City of Hiawatha

Re: **Sherman Square 9th Addition**

Description: **Approval of Plan of Improvements (REVISED)**

PLAN OF IMPROVEMENTS
SHERMAN SQUARE NINTH ADDITION
TO THE CITY OF HIAWATHA, LINN COUNTY, IOWA

SHEET 9 / 10

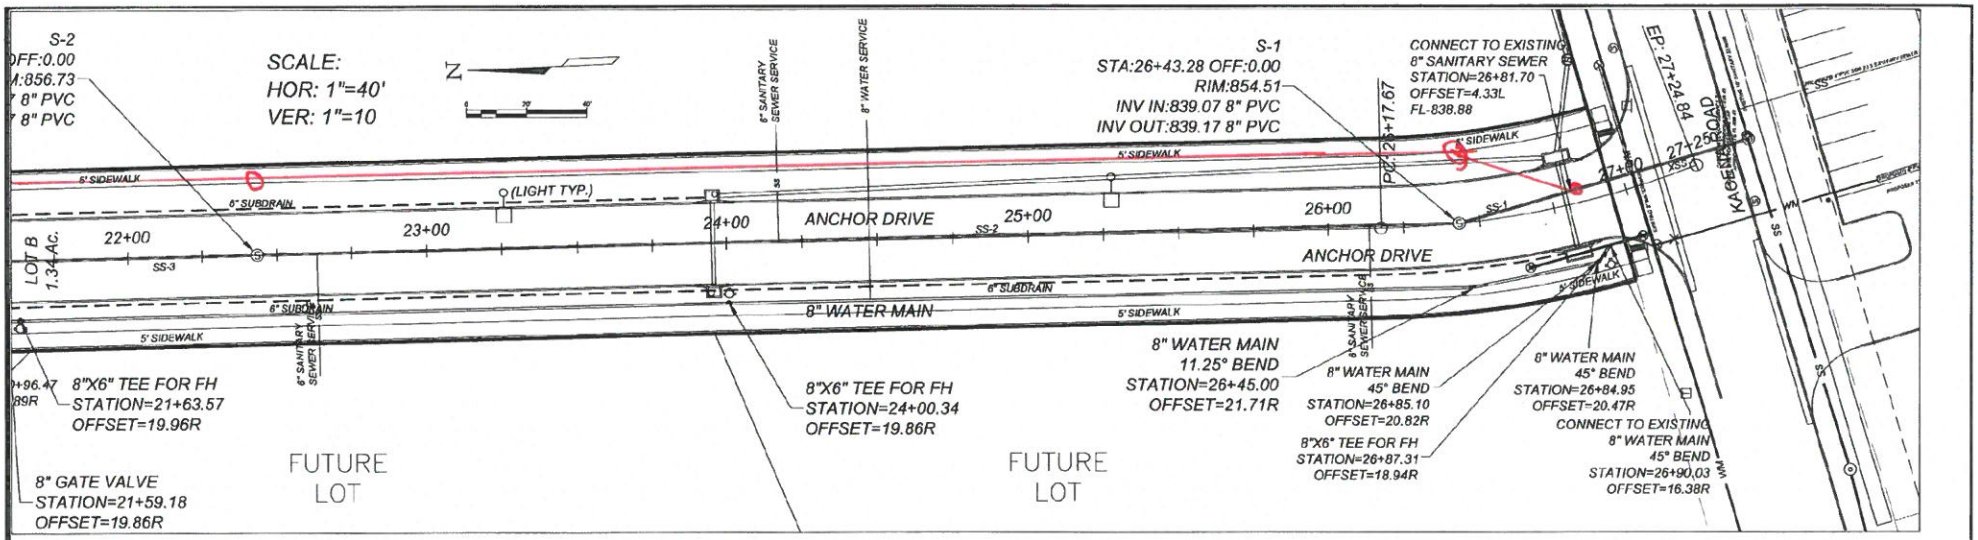
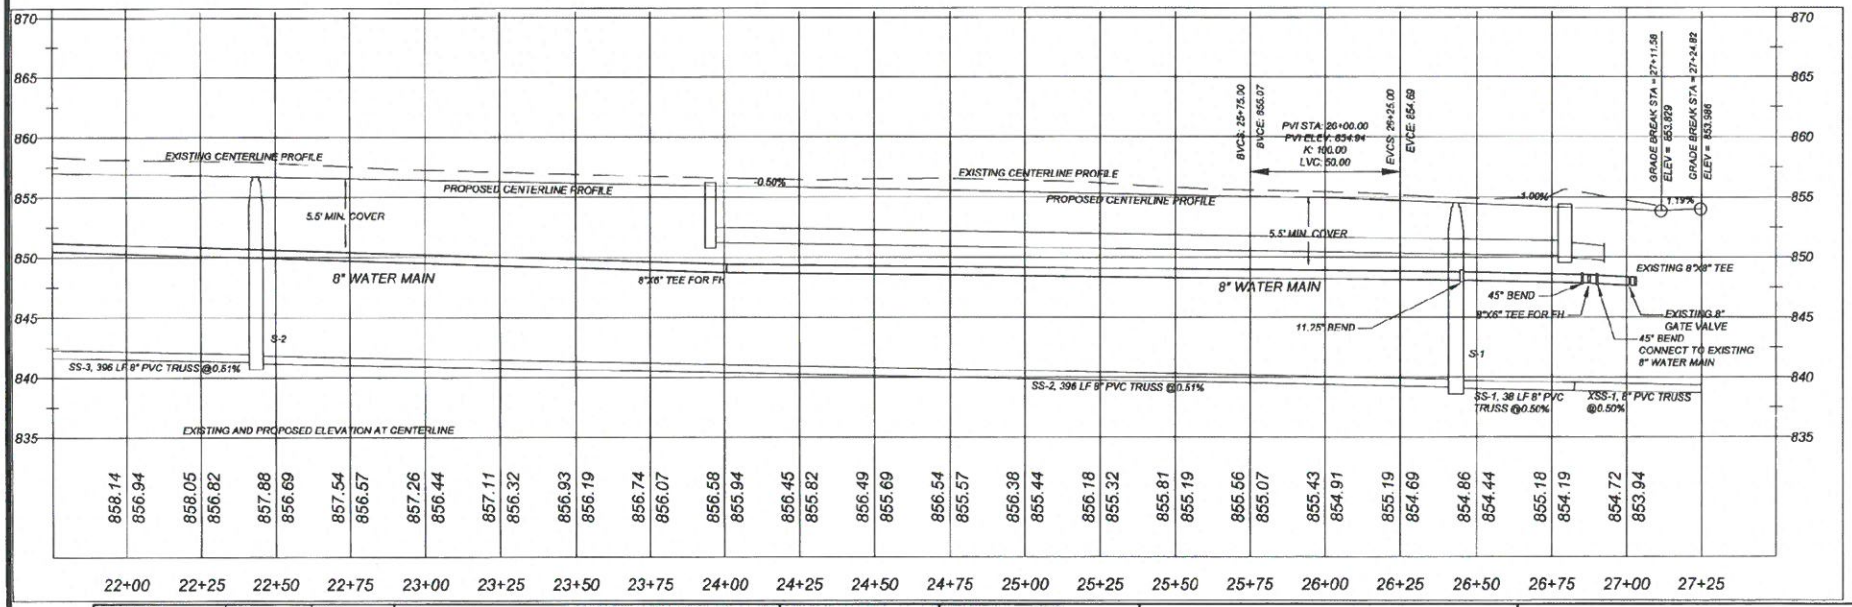
After construction has started on Sherman Square 9th Addition, very wet soil conditions and water table was encountered at a very shallow depth. For that reason, the developer requests a plan revision to relocate the utilities to reduce that volume of soil replacement under the new street. Revision included in the plans:

- The sanitary sewer has been designed along the east side of Anchor Drive in the grass parking area.
- Revise the sewer services to the new World Class Industries building.
- Angles in the sewer alignment meet IDNR requirements.

NO.	REVISION DESCRIPTION	BY	DATE
1	UPDATED SANITARY SEWER, SANITARY SEWER SERVICES AND WATER SERVICES	DFB	8/09/18

Engineering has reviewed the developer's request and revised plans. The relocated sewer is not a concern for the City. The wet weather we have encountered in recent months has caused a concern for construction projects. By eliminating the large excavation in the centerline of the street, the soil conditions will be improved hopefully reducing the stresses that cause a new street surface to crack. All future lots will be provided sewer service as planned in the original design.

Engineering has reviewed the revised plans and recommends approval.

SHEET 8 / 10

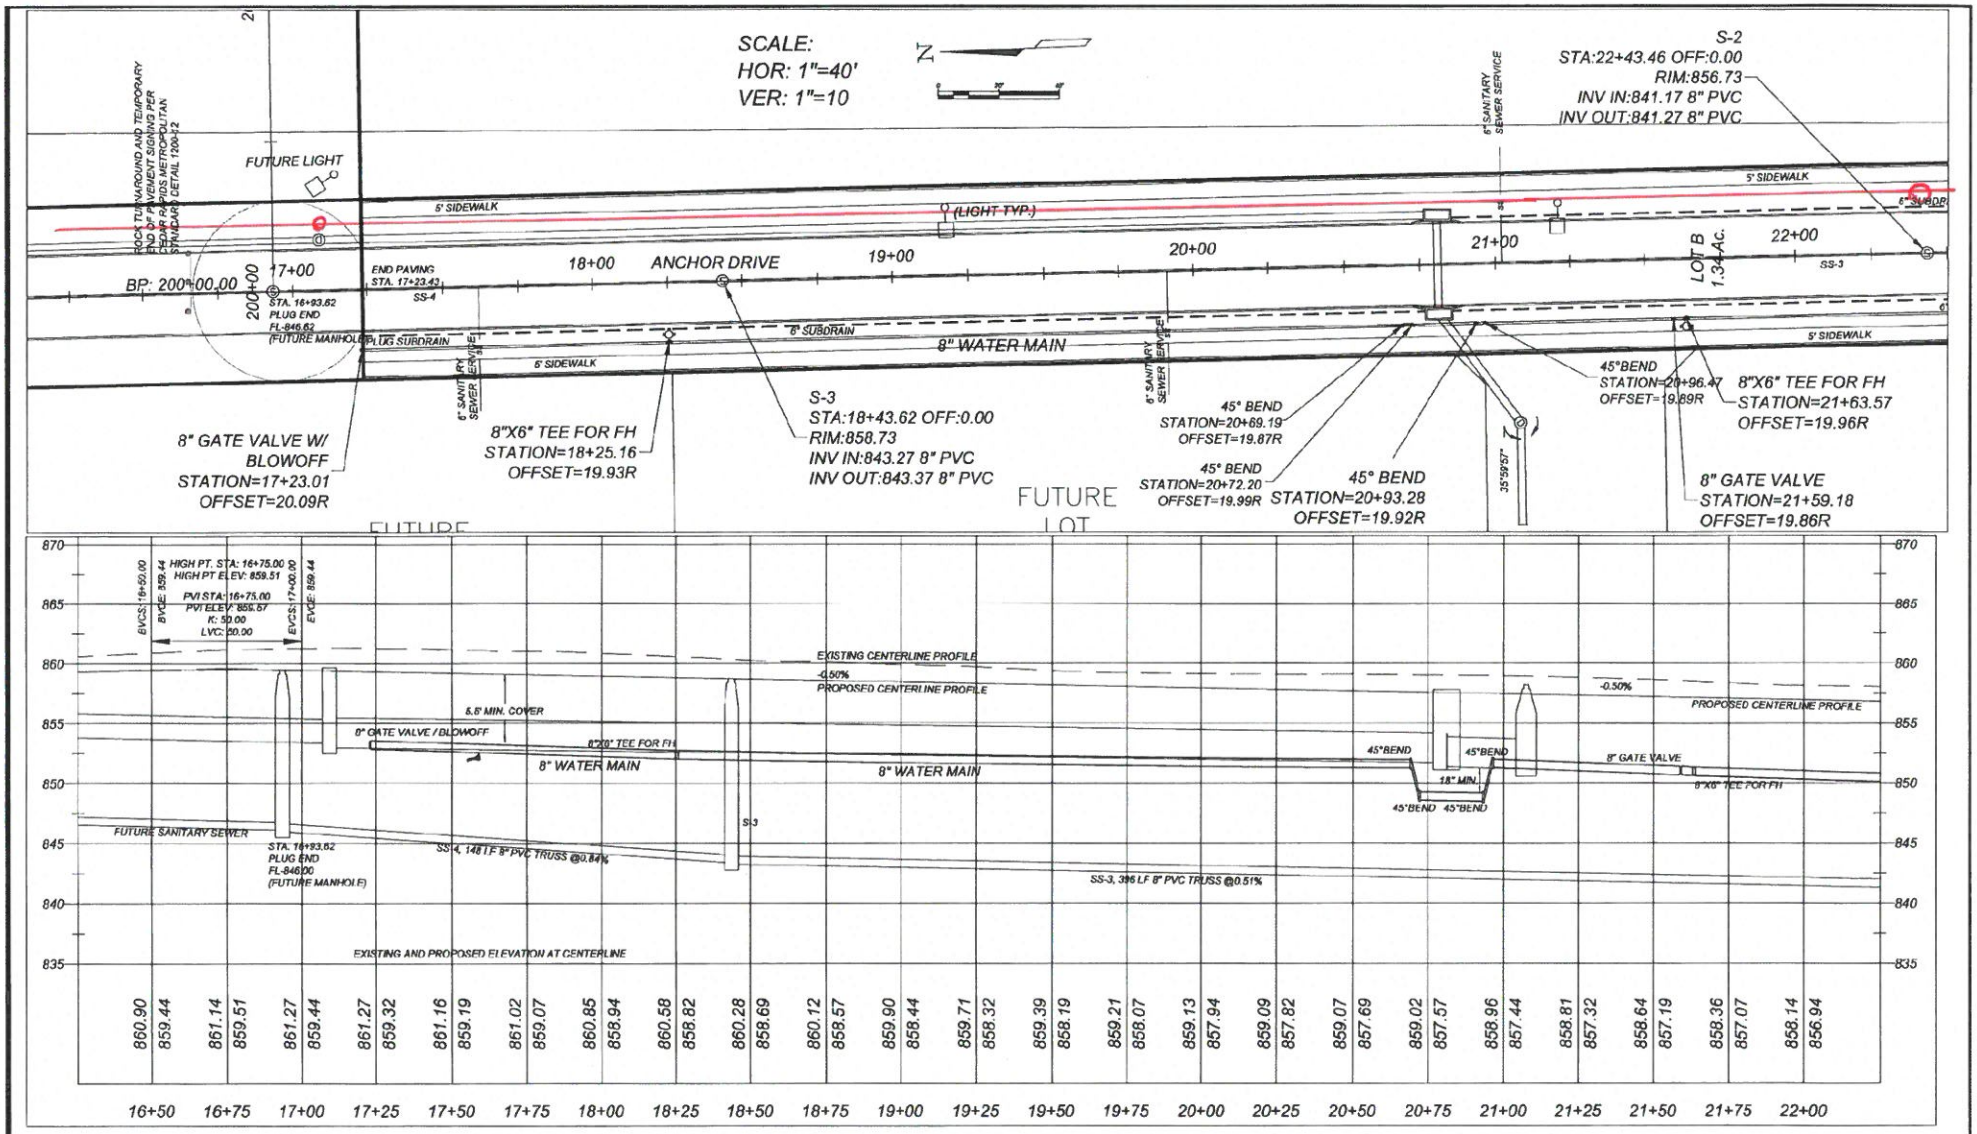
NO.	REVISION DESCRIPTION	BY	DATE
1	UPDATED SANITARY SEWER, SANITARY SEWER SERVICES AND WATER SERVICES	DFB	8/20/18
